VN(4) Hood Ventilation Grille Replacement

Section 821

Introduction

VN4 Hood Ventilation Grille Replacement

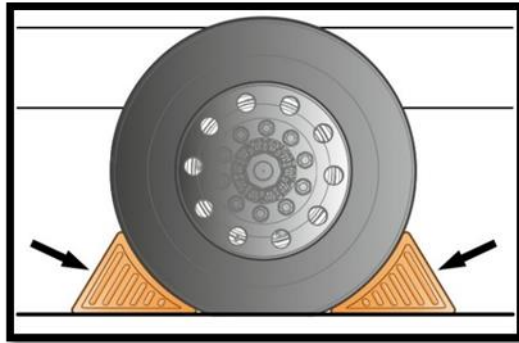
Volvo Trucks North America has developed an updated Hood Ventilation Grille that utilizes a mesh insert for VN(4) model vehicles. Please refer to the repair instructions in this document to replace the Hood Ventilation Grille.

Part Numbers	Part Names	Quantity
24655526	Hood Bezel	1
